Spokane Park Board Agenda

3:30 p.m. Oct. 11, 2018

Design-Build Change Order Form

Change Order Number: 9	Change Order Effective Date: 10/15/18 (date when executed by both parties)
Project: PAVILION DESIGN BUILD PROJECT	Design-Builder's Project No: 172100
	Date of Agreement: APRIL 13, 2017
Owner: CITY OF SPOKANE - PARKS & RECREATION DIVISION	Design-Builder: GARCO CONSTRUCTION, INC.

Client: CITY OF SPOKANE Date: 9/11/18
 Project: HOWARD ST SW REM Project No: 17-21-02
 Subject: NORTH ABUTMENT Page: 1/2

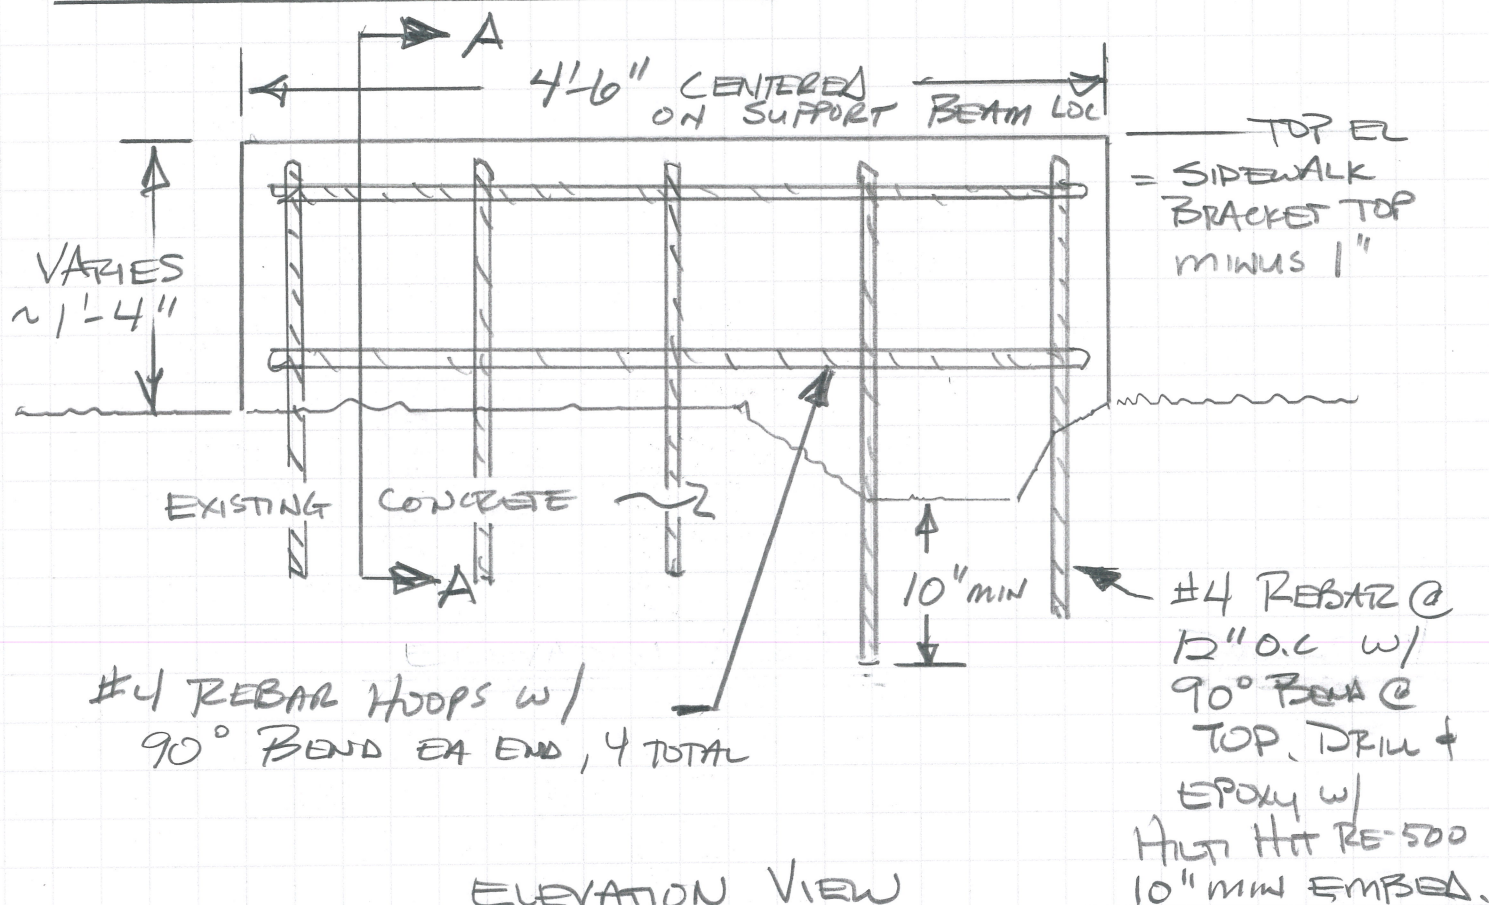
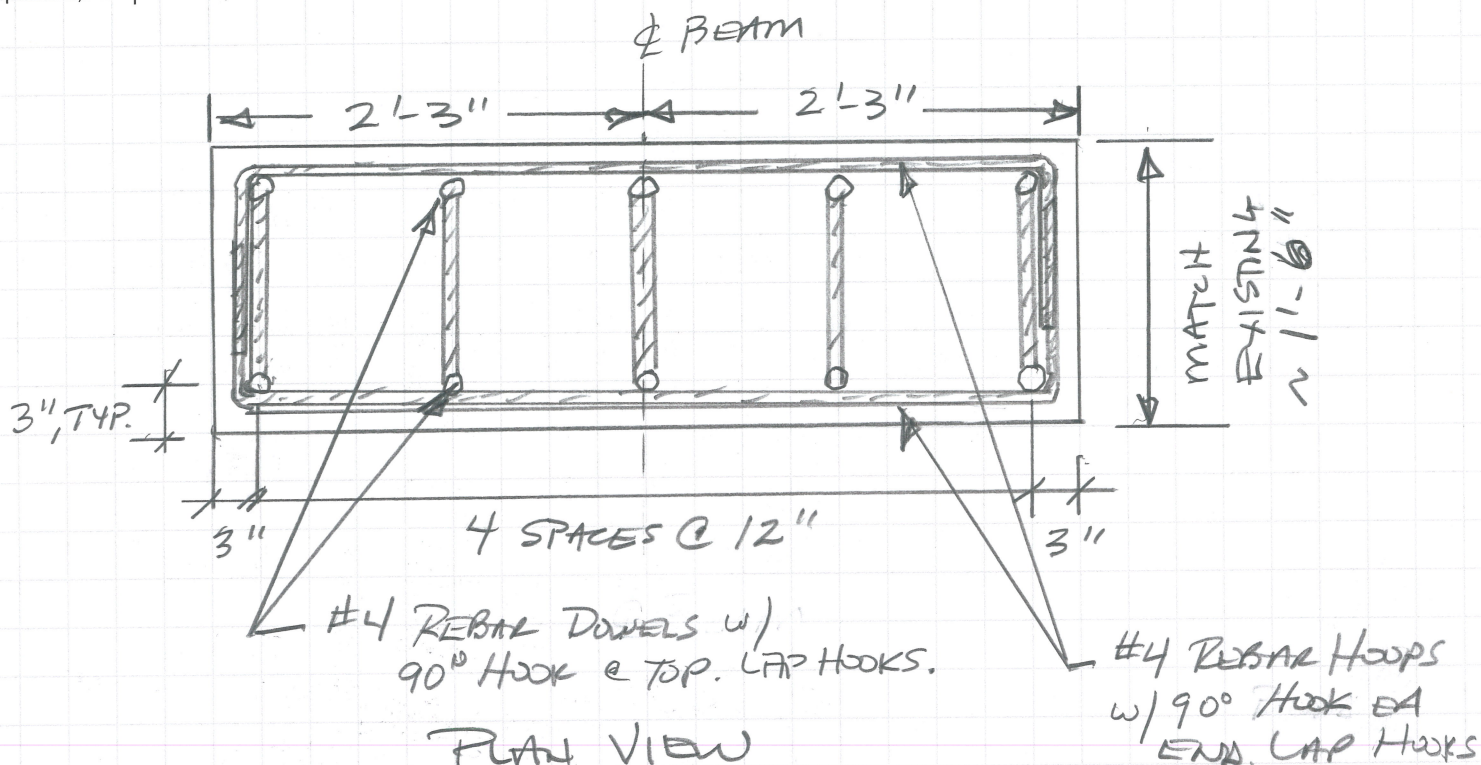
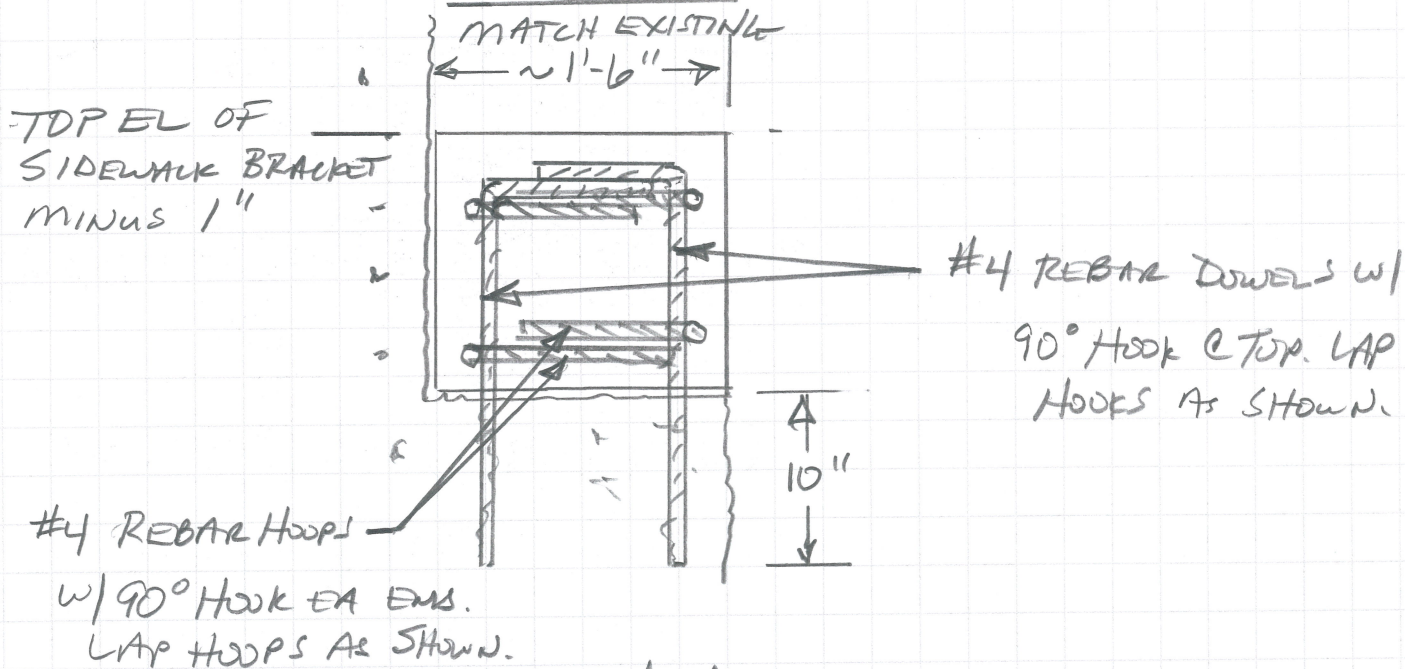
Following removal of the northeast approach sidewalk section, Garco has investigated the suitability of the existing bridge abutment for supporting the beam that carries the waterline. Reference the attached pictures for the existing conditions. The abutment has been added on to a couple of times, and those portions are in bad repair as well as conflicting with the details for the beam support in our plans. After a field review with Mark Serbousek, City of Spokane, Garco is proposing the following steps be taken to address this issue (reference attachments shown in the North Abutment Repair Package file):

- Remove the added concrete pours and existing steel post as shown on the Demolition Limits picture.
- Patch and grout the existing concrete surface as necessary to produce a uniform profile as shown in the Repair Plan.
- Dowel rebar, form and place a concrete plinth as shown in the Repair Plan and Plinth Details.

ADDED CONCRETE PLINTH FOR BEAM SUPPORT:

- REBAR = #4 GR. 60
- EPOXY FOR DOWELS = HILTI HIT RE-500
- MINIMUM EMBEDMENT FOR DRILLED REBAR = 10"
- FIELD BEND REBAR AS REQUIRED.
- CONCRETE - 4000 PSI MINIMUM, 1" ϕ MAX AGGREGATE
- INSTALL ANCHOR BOLTS & GROUT PAD AS SHOWN ON SHEET D4, BEARING DETAIL 3/4 OF PLANS.

FLOOR PLAN - WEST BLDG - NW - LOWER LEVEL - POWER

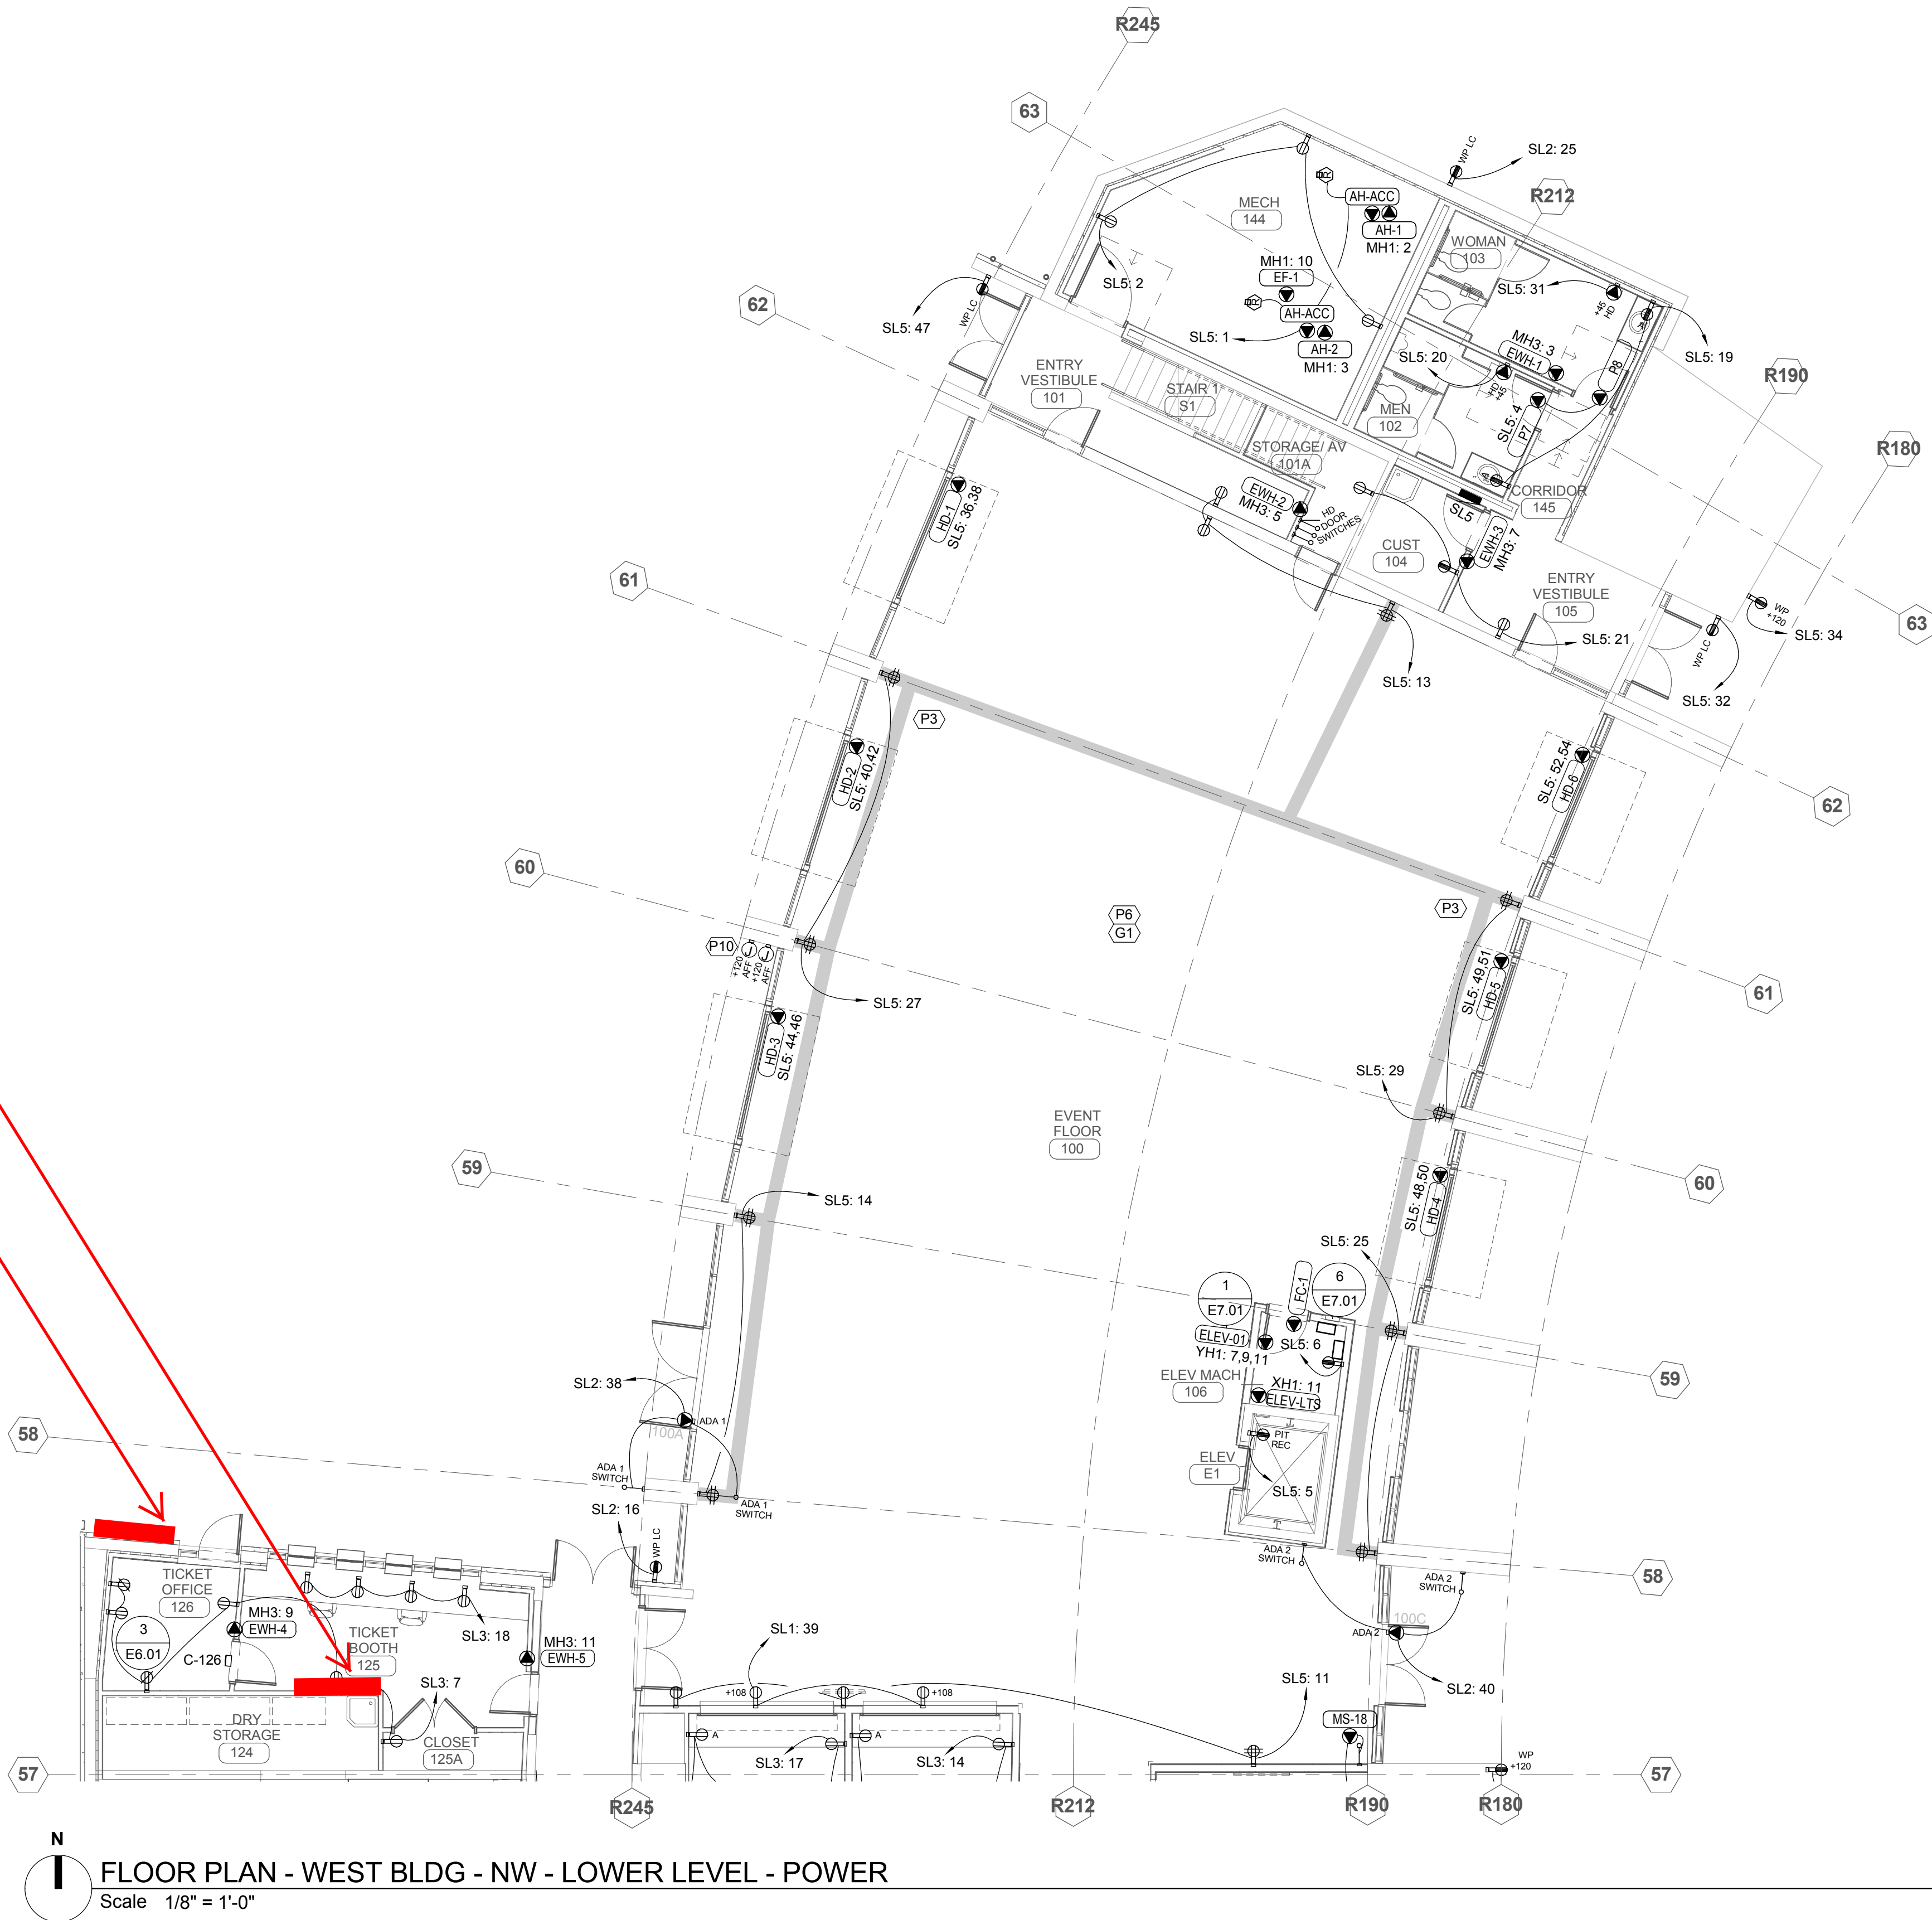
CURRENT EVENT DISPLAY MONITOR
REQUIRED IN THIS LOCATION.
DATA AND POWER REQUIRED.
PLEASE HAVE NAC PROVIDE CONCEPT/
RECOMMENDATION.

FUTURE EVENT DISPLAY MONITOR
REQUIRED IN THIS EXTERIOR LOCATION.
DATA AND POWER REQUIRED.
PLEASE HAVE NAC PROVIDE CONCEPT/
RECOMMENDATION.

Description: Provide pricing to design and install the signage noted on the attached Signage Coordination Drawings dated September 21, 2018. This is in addition to other signage noted in the review comments. Please note that the power and low voltage rough-in for the signage at the NE Entry was part of the Validation scope.

FLOOR PLAN - WEST BLDG - NW - LOWER LEVEL - POWER

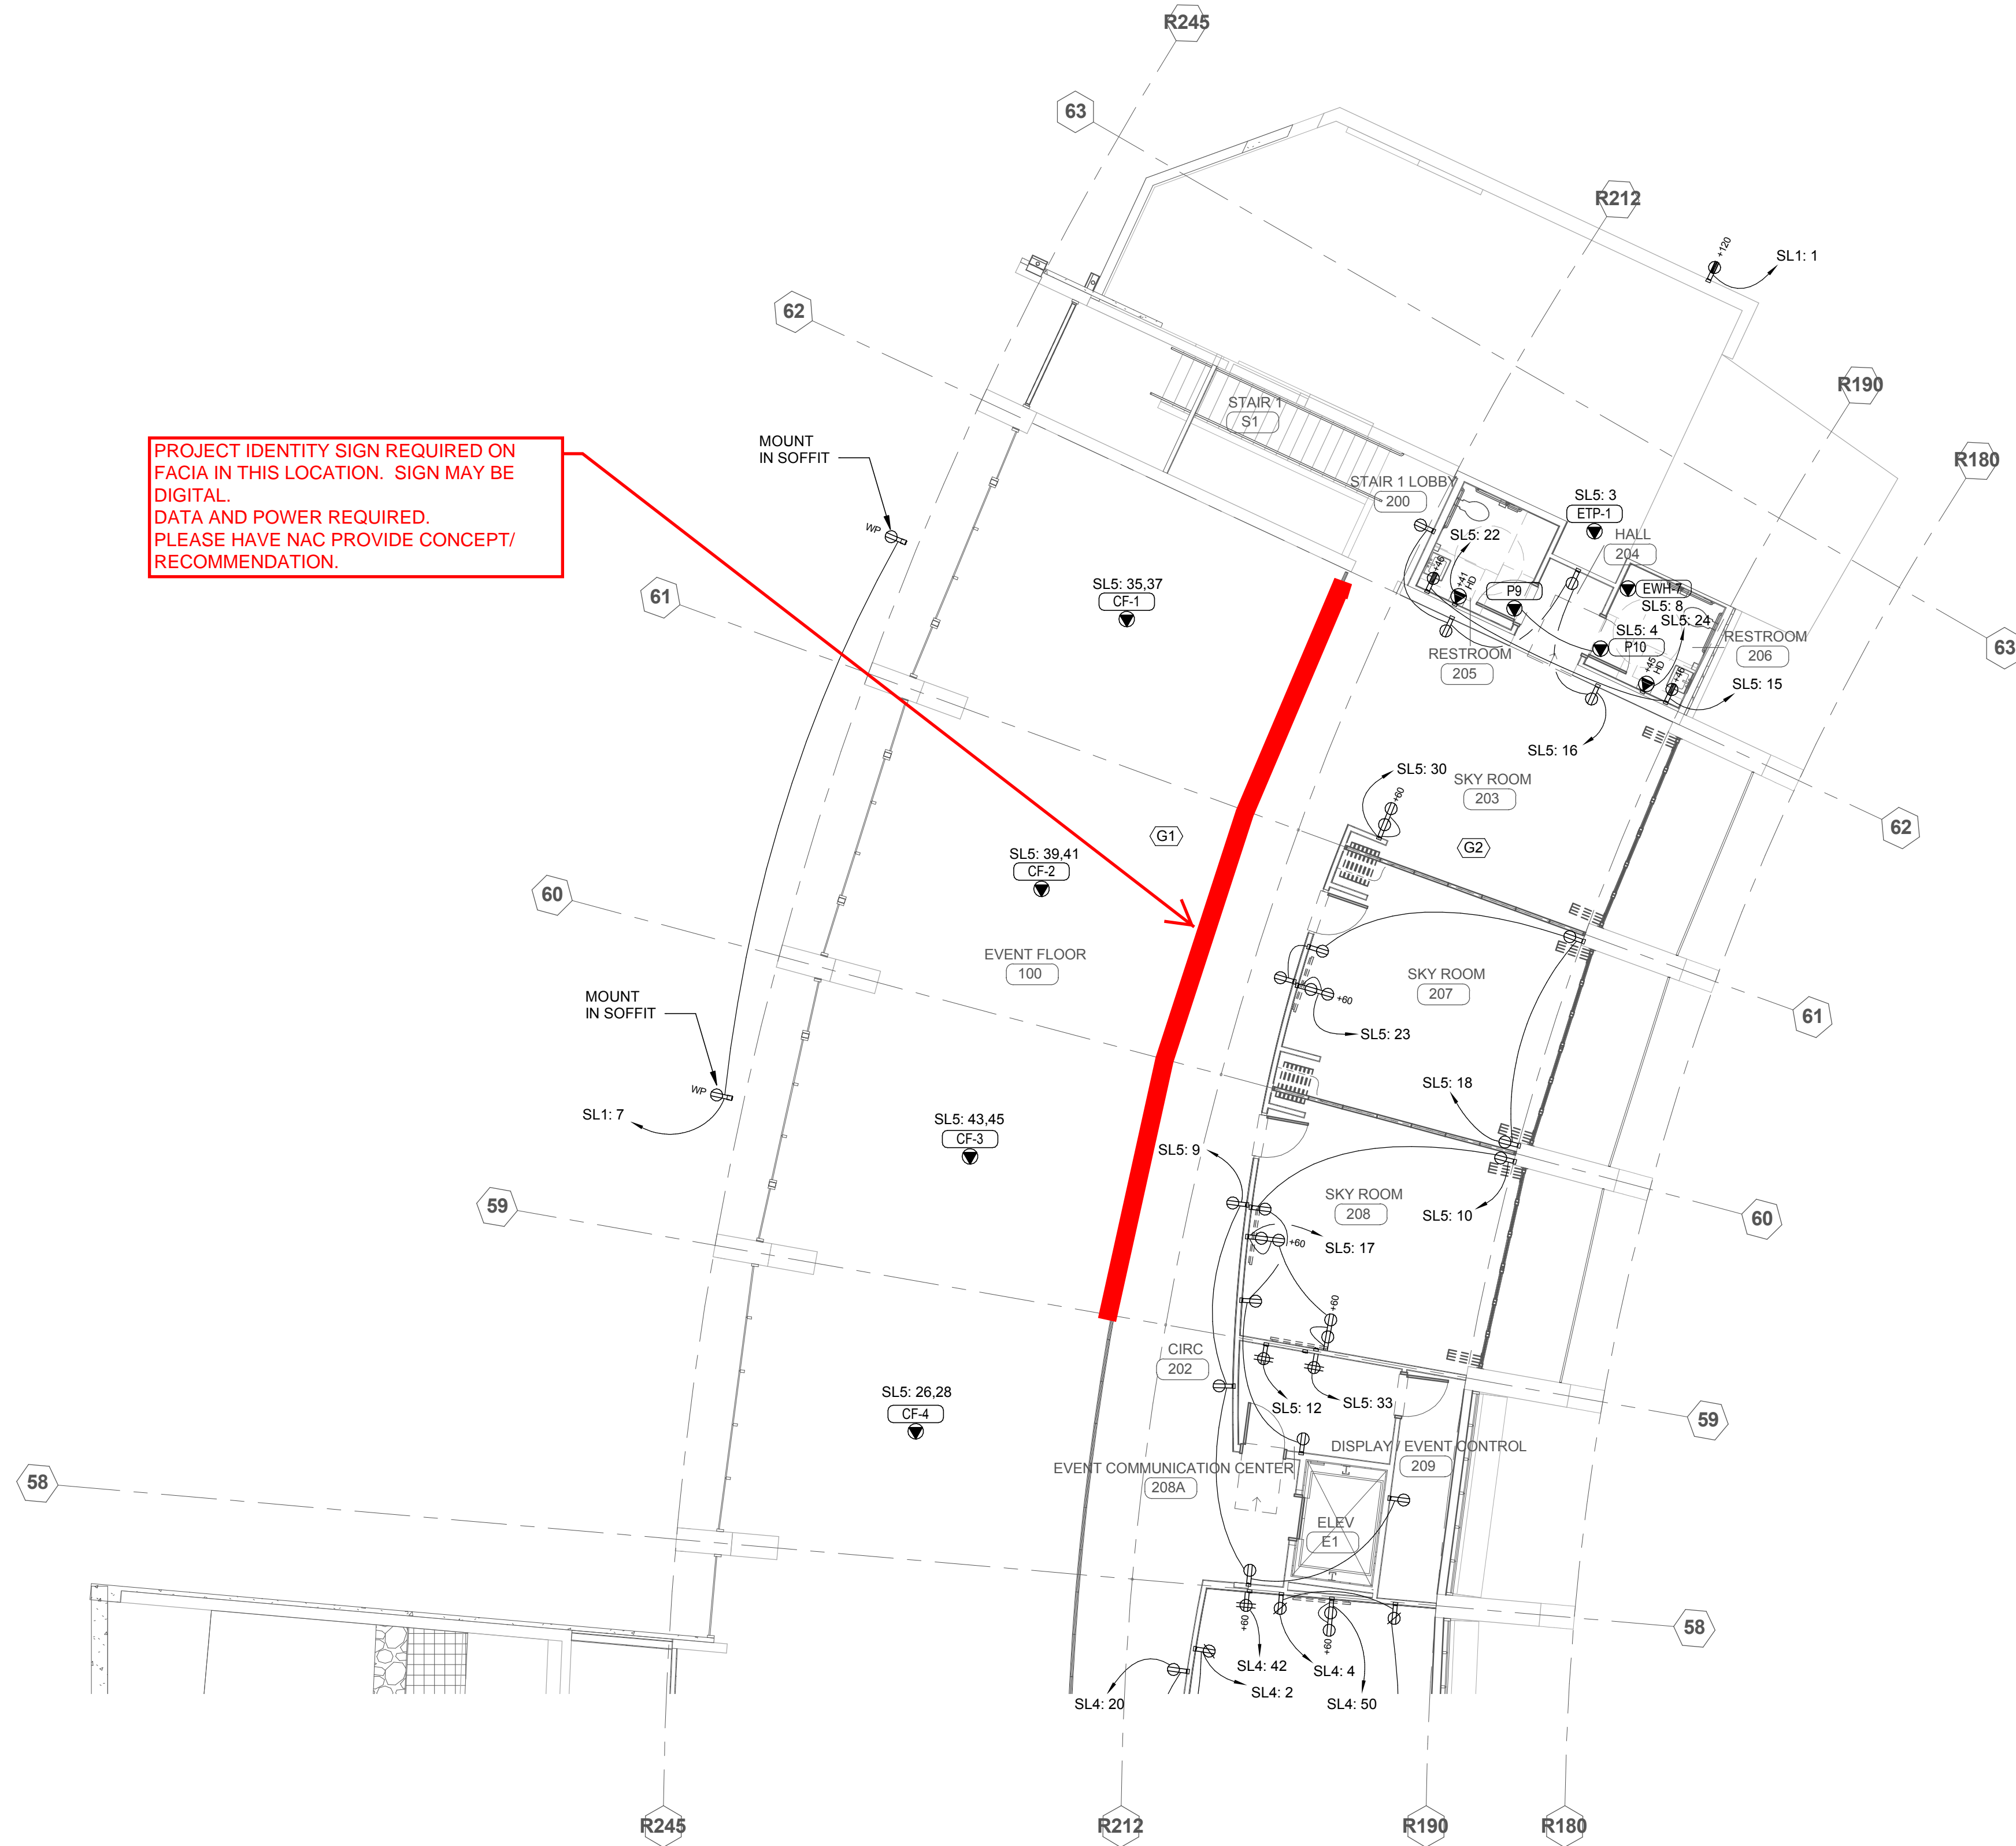
PROJECT IDENTITY SIGN REQUIRED ON
FACIA IN THIS LOCATION. SIGN MAY BE
DIGITAL.
DATA AND POWER REQUIRED.
PLEASE HAVE NAC PROVIDE CONCEPT/
RECOMMENDATION.
